HEARING REPORT

5 REEVES ROAD, PAKURANGA HEIGHTS (EB2)

**AUCKLAND TRANSPORT
IN CONJUNCTION WITH
EASTERN BUSWAY ALLIANCE**

Hearing Report for Resource Consent under section 88 of the Resource Management Act 1991 (RMA) and Notice of Requirement under section 168 of the RMA by Auckland Transport for designation in the Auckland Unitary Plan for a public work, being the construction, operation, and maintenance of Eastern Busway 2 on land between the intersection of Ti Rakau Drive/SEART and Pakuranga Road/William Reeves Road, Pakuranga).

Figure 4: Retaining wall RW211 located adjacent to 101 Ti Rakau Drive. Esplanade reserve highted in light blue.

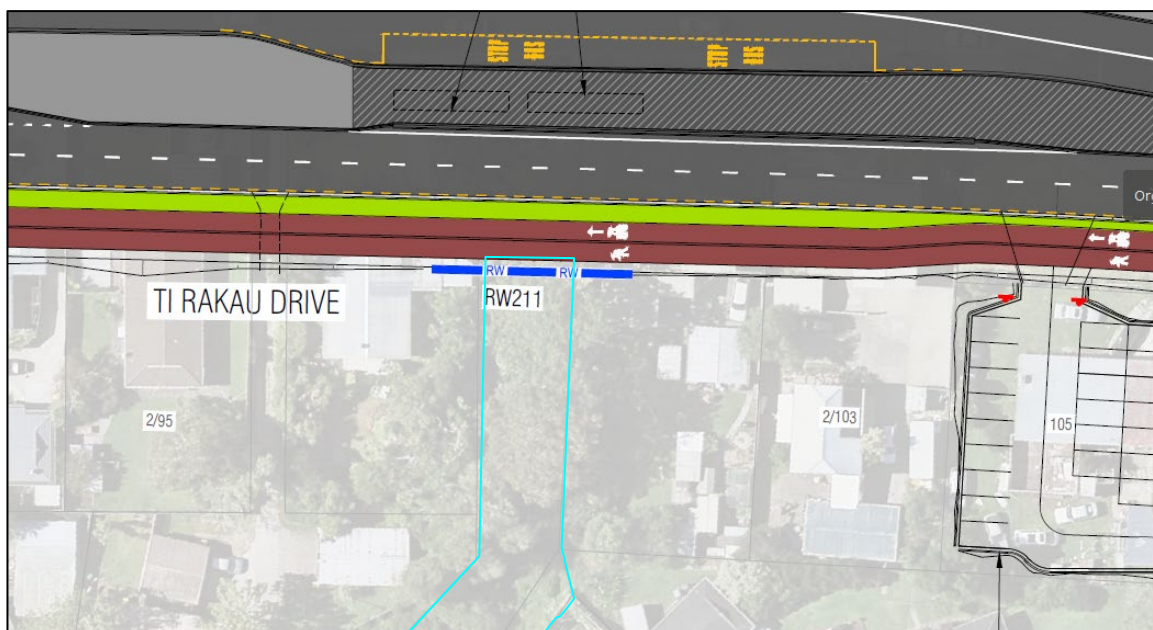
length of 20m⁵. Whilst there is limited public access to this part of the reserve now, the introduction of the wall has the potential to constrain the delivery of a recreational walking and cycling connection in accordance with the HWCN plans. This is not supported and has the potential to diminish the potential future public use and enjoyment of the esplanade reserve - being presently unmitigated. A cross-section of this area might have assisting in understanding this further. **Figure 4** shows the location of the wall. The UDPL condition could be updated to include a review of this wall but there is presently insufficient information available to understand how the wall would maintain future public access.

- 6.18. A large tree would be removed from the northern part (adjacent to the existing bus-stop) of the esplanade area to complete the works, but its loss would be mitigated over time by the proposed 3:1 replacement planting offered by the applicant.

Figure 1: Proposed access arrangements for the Bampton Road/Pakuranga Road accessway

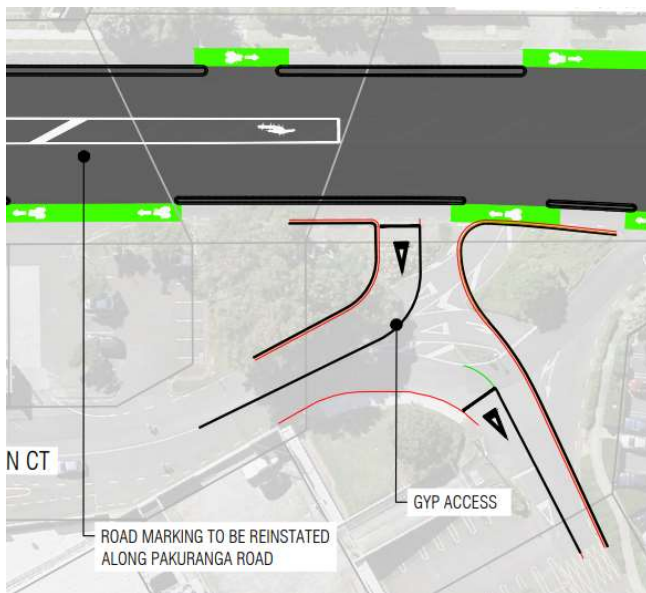
"Inefficient operation of the Pakuranga Road access resulting in adverse effects on the safety and efficiency of the transportation network"

The applicant has made changes to the design of the Pakuranga Road accessway in the updated ITA which has been provided to Stantec for review on behalf of Council. The intersection will be realigned to provide improved access to vehicles turning right from Pakuranga Road eastbound. The east Brampton Court access will provide for both inbound and outbound movements (while the current arrangement only permits outbound movements) and will improve the efficiency of the accessway as illustrated in the following Figure 1.

The changes proposed by the Applicant to the access points associated with the Pakuranga Plaza, including the signalization of two accesses, are considered to lead to an overall improvement in capacity and accessibility of the Pakuranga Plaza complex. As such, it is considered that the Applicant has taken appropriate measures to improve the safety and efficiency of this intersection.

Figure 1 Proposed intensive residential zoning along Ti Rakau Drive, extending across whole catchment

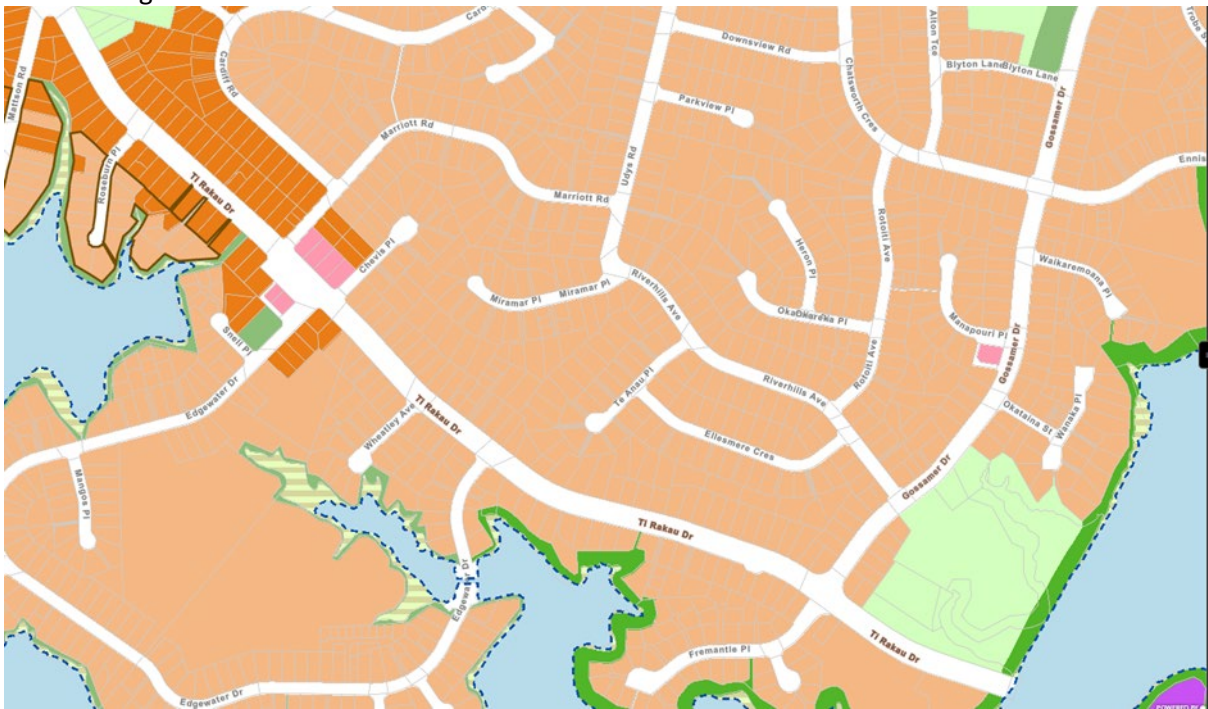
The future built context of these roads will be substantially different to that which currently exists. Land along the eastern side of William Roberts Road (North) and along the western side of Ti Rakau Drive adjacent to the Pakuranga Town Centre currently has stand alone and semi-detached houses, but the AUP-OP zoning is Business – Mixed Use. Business – Mixed Use zone allows for five storey buildings. For most of the rest of Ti Rakau Drive, within EB3R, there are also mainly stand alone and semi-detached houses flanking the road. However the Residential – Mixed Housing Urban zone and the new Medium Density Residential Standards (MDRS) plan change allow for many more houses and larger buildings, in many cases as permitted activities (the existing environment). There is a sufficient step in scale and intensity to incentivise redevelopment of the existing houses. This is not speculative or fanciful, although the fine-grained pattern of land ownership may mean that intensification occurs over a longer period of time than would be likely in a greenfields location. The operative Residential – Mixed Housing Urban zone is currently only a one to three house depth corridor along Ti Rakau Drive, with the AUP-OP reducing to the more suburban Residential – Mixed Housing Suburban zone further away from the road. However, the MDRS Plan Change 78 extends the more intensive zoning to

all of the land within the walkable catchment of Ti Rakau Drive, as shown in Figure 1 below.

The urban design implications of that three storey intensive re-development flanking Ti Rakau Drive, and five or more storey adjacent to the Pakuranga Plaza, include increased vulnerability to loss of the larger trees on private land, and a greater need for larger trees within the public realm, on streets and in parks. The wider scope of residential intensification will also mean many more people within the walking catchment of the busway stations.

Figure 2 Screenshot Few street trees northern side of Ti Rakau Drive

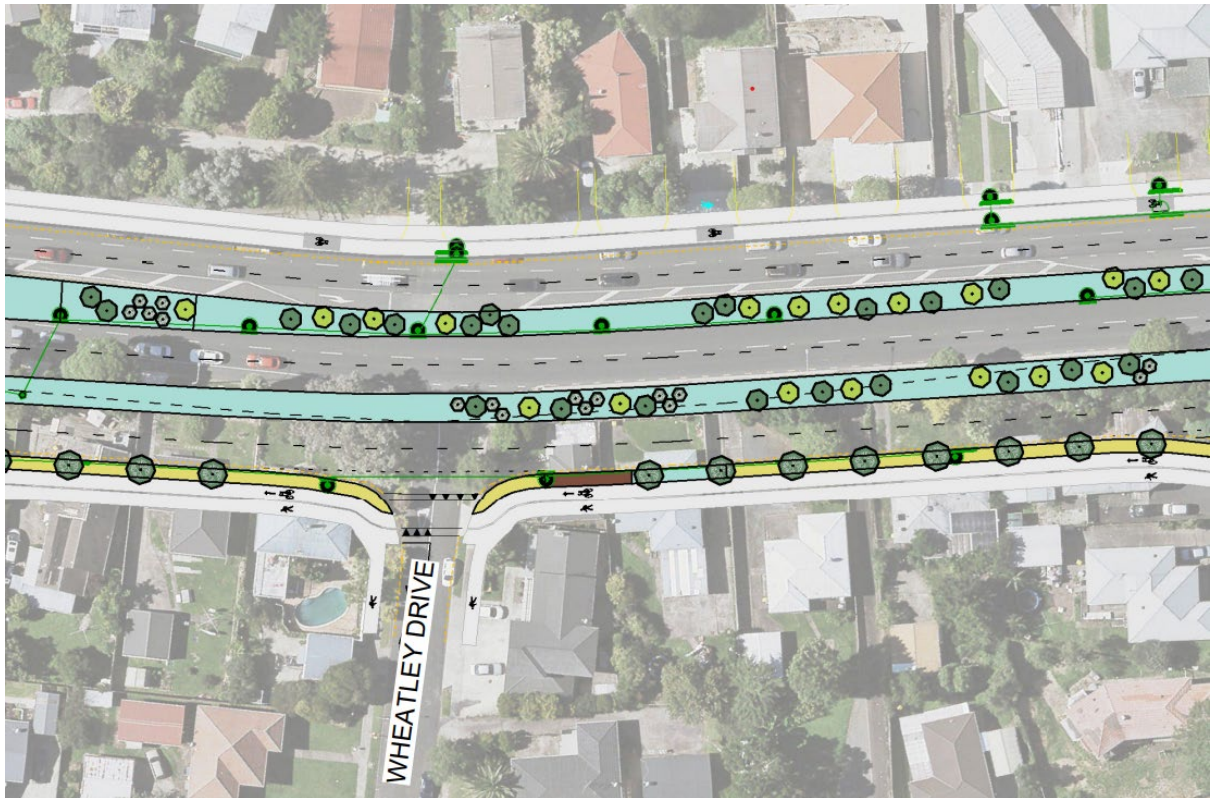
- 4.39. There are also considerable stretches of Ti Rakau Drive with no large or medium street trees proposed, and particularly along the northeastern side of the road, where there is little new land taken and the existing berm appears to be largely taken up by walking and cycling facilities. AEE at 3.2.1 states there will be eastbound existing footpath to remain, a new 2.0m wide segregated cycleway and a 1.0m berm separation from traffic lanes. The AEE accompanying reference diagram Figure 3-2 is not of the general road cross-section but of a Ti Rakau Drive Bus Station, with an existing 3.5m footpath and berm to remain and a new 2.0m wide cycleway with an additional 1.0m separation from the traffic lane.

- 4.40. Figure 2 below shows a sample of Ti Rakau Drive proposed street tree planting (from AEE Appendix 5 Landscape, Ecological & Arboricultural Mitigation Plans), with a scarcity of large trees, or any trees along the northeastern side of parts of Ti Rakau Drive. The small green dots on the northeastern side are not trees, but are not referenced in the plan legend, so may be from some other infrastructure asset map. The footpath and cycleway appear to take up almost the whole of the northeastern berm. This effect is exacerbated by the counting of privately-owned trees as being retained and the dismissal of quantities of unprotected (smaller) street and parks trees by removal as a permitted activity or permitted baseline: The Applicant's Master Tree Plan (AEE Appendix 16) shows street trees in red to be removed and both public and private trees in green to be retained. Many of these private trees "to be retained" are outside of the control of the Applicant, are not protected by any rule in the AUP-OP, and will be vulnerable to loss when intensive redevelopment of those properties occurs.

- 4.41. Along Ti Rakau Drive, from its intersection with Pakuranga Road, there are few new street trees proposed along the western side of the road, with all being allocated to the eastern side of the road or within medians and traffic islands. There is a narrow grassed berm along the western side, mainly in the existing location of the road edge, and not really usable for tree planting as it is directly adjacent to the kerb and trees would hang over the road. The Ti Rakau Corner Reserve at the intersection has some large trees. Then moving southeast along Ti Rakau Drive, the AEE Appendix 16 Arborlab Master Tree Plan shows 12 trees to be removed along the west side of the road, and no new trees (in AEE Appendix 5 Landscape, Ecological and Arboricultural Mitigation Plans) on the street edge until the reserve adjacent to the Ti Rakau Drive Off Ramp at SEART. SEART and the southeastern side of Reeves Road are the boundary between EB2 and EB3R. Then it is along the EB3R western edge of Ti Rakau Drive another 200 metres before a new street tree is proposed. Moving further southeast along Ti Rakau Drive, there are then a good number of new street trees proposed along the southwest side of the road but a dearth along the northeast side of the road. Again, the berm does not appear to be provided with sufficient width to accommodate new street trees of any substantial scale, being almost wholly taken up with the footpath and cycle facilities. This omission of new street trees along the northeast side of the road continues until the frontage of Riverhills Park at Pakuranga Creek. At Riverhills Park the proposed busway and station occupy the frontage of the park, including removal of the parks trees along that frontage and replacement with a 'potential lizard relocation zone' and some mitigation by fourteen 80L trees in a grove on the esplanade alongside Pakuranga Creek.

Figure 1: Proposed locations where heavy truck movements will avoid during 8.25am - 9.00am and 2.55pm - 3.15pm

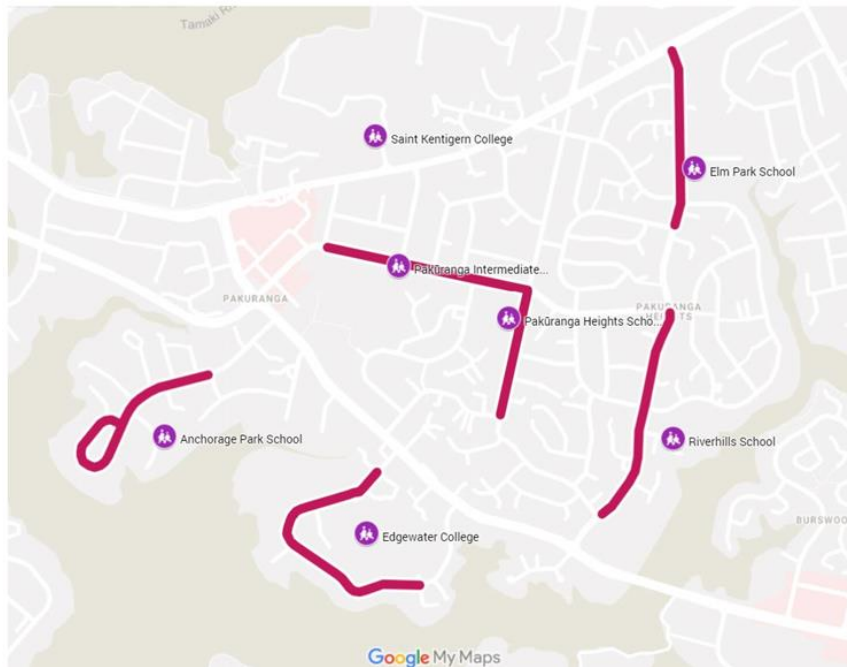
EBA’s Construction Traffic Management Plan (CTMP) outlines how all heavy truck movements should avoid schools between 8.25am - 9.00am and 2.55pm - 3.15pm during term time. Figure 1 below shows the roads which heavy vehicles are proposed to avoid during these times. The Ministry supports EBA and AT’s willingness to prioritise the safety of students at Elm Park School, Riverhills School, Edgewater College, Anchorage Park School, Pakuranga Heights School and Pakuranga Intermediate.

However, the Ministry still have concerns relating to construction traffic around Pakuranga Heights School, Pakuranga Intermediate, Elm Park School and Riverhills School. Reeves Road is an identified construction route for the project. The CTMP states that Reeves Road will carry roughly one construction vehicle every six minutes, either in the westbound or eastbound directions at the peak of construction. Pakuranga Intermediate is located on Reeves
